INITIAL APPRAISAL OF THE IMPACTS ON LYNDHURST
HALL OF THE PROPOSED BASEMENT CONSTRUCTION AT
11 ROSSLYN HILL, NW3

Prepared for
Richard Boote

Project no.
1580

Date
27 May 2015

Figure 2: Approximate ground movement due to installation of underground swimming pool adjacent to the vaulted main studio of Lyndhurst Hall

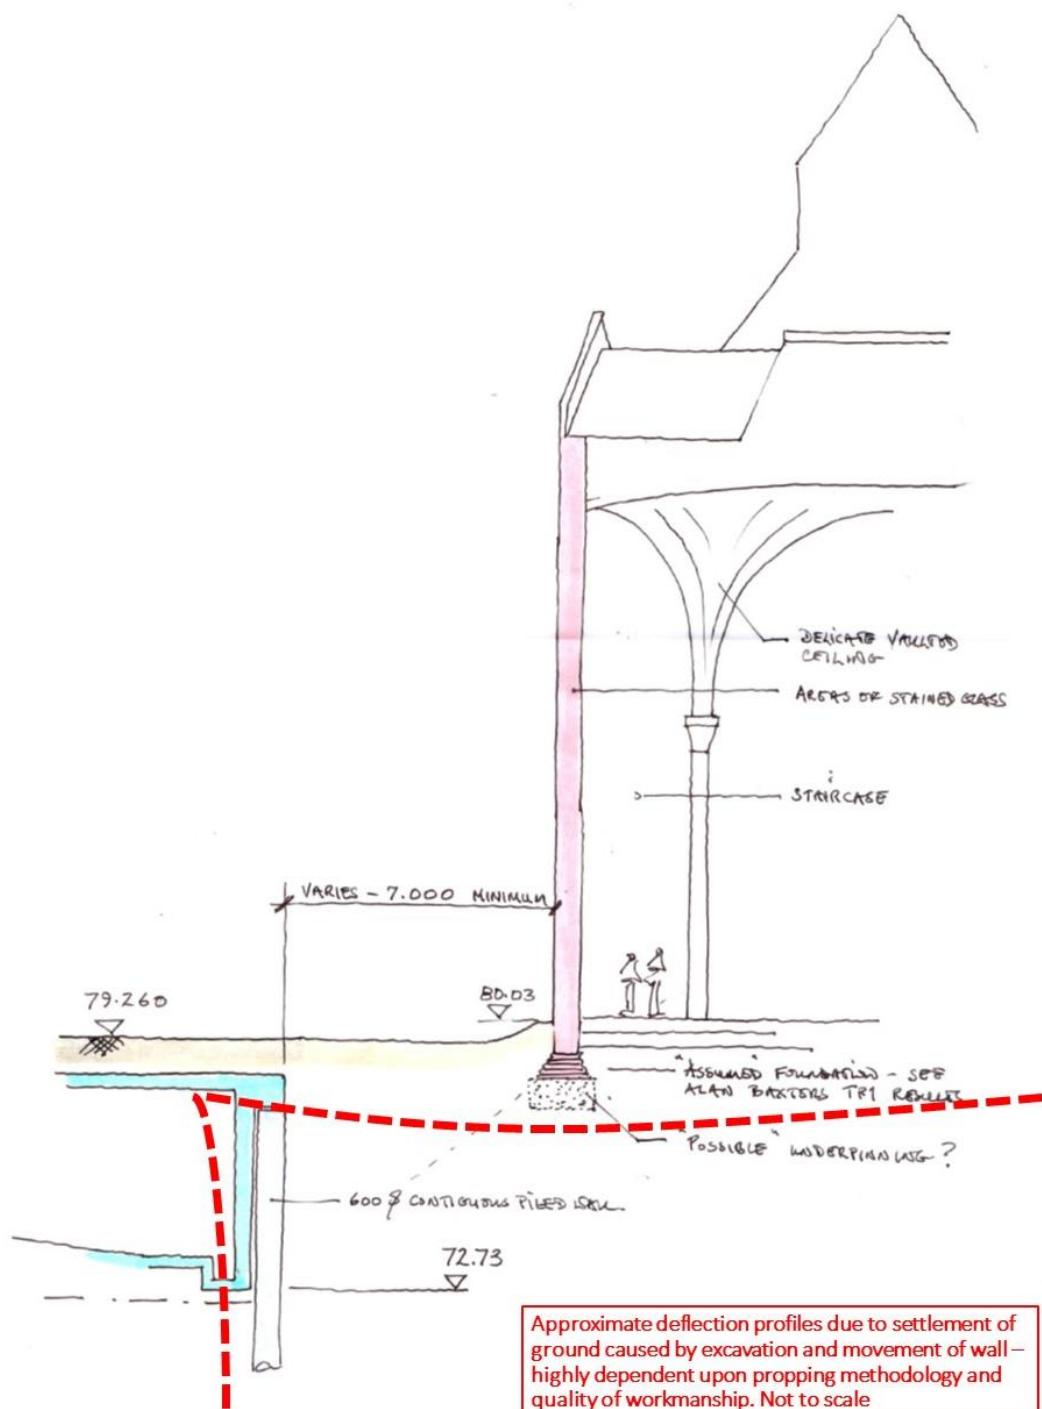
Contained within the BIA is a crack assessment using the Burland scale, related to the length of Lyndhurst Hall, following a process set out in a CIRIA technical guide; however, no consideration has been given to ground movements, horizontal or vertical, on the stability or cracking of the triple height vaulted roof structure of Lyndhurst Hall main studio. See figure 2 below for an approximate assessment we have sketched out based on the limited information to hand.

It is well known that the Burland damage assessment procedure cannot be used on its own as a direct measure of damage to property yet this is the only approach used in the BIA.

Figure 3: Sketch showing proximity of new underground cinema in relation to the foundations of Lyndhurst Hall (including various measurements taken from BIA)

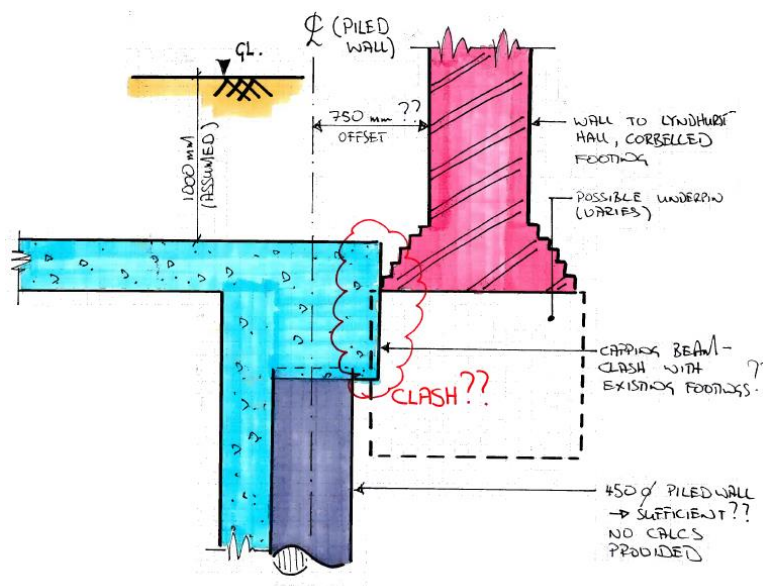
The foundation construction of Lyndhurst Hall will strongly influence the proposed adjacent basement design and construction and requires more extensive consideration in the BIA. Where the foundations are shallower they may not prevent perched groundwater flows through the made ground layer over the London Clay beneath our Client's building, as assumed in the BIA, and where there are underground features this needs to be considered properly in the design, construction and location of the new basement. See figure 3 below for a detailed section showing the existing foundations and the proposed basement, deduced from the information provided, which suggests that the basement is too close to Lyndhurst Hall.

Figure 4: Potential undermining of foundations to Lyndhurst Hall during construction of adjacent basements (depending upon extents of existing concrete footings)

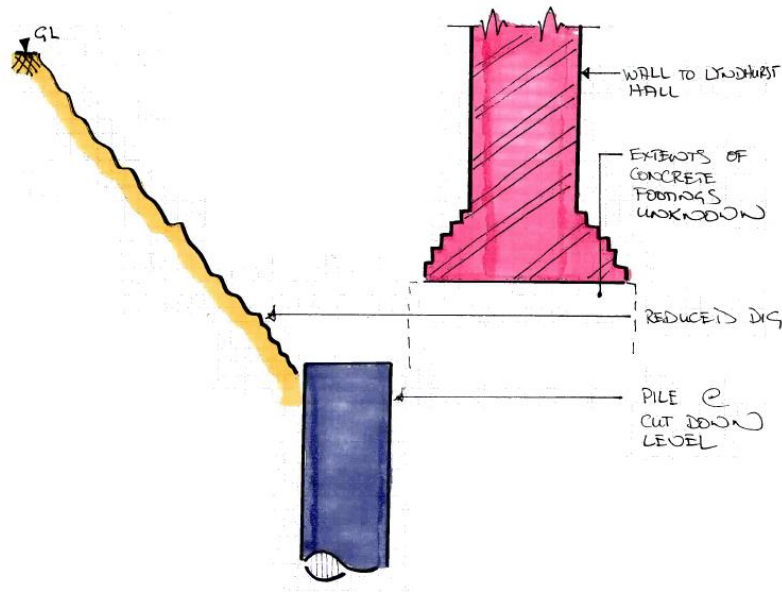
The proposed basement drawings describing the cinema show this to be located extremely close to our Clients' building; further study may show

this to be too close – the proximity will make it practically very difficult to construct as can be seen from the sketch in figure 4 below, as the extents of the concrete underpinning to Lyndhurst Hall has not been investigated in the BIA.
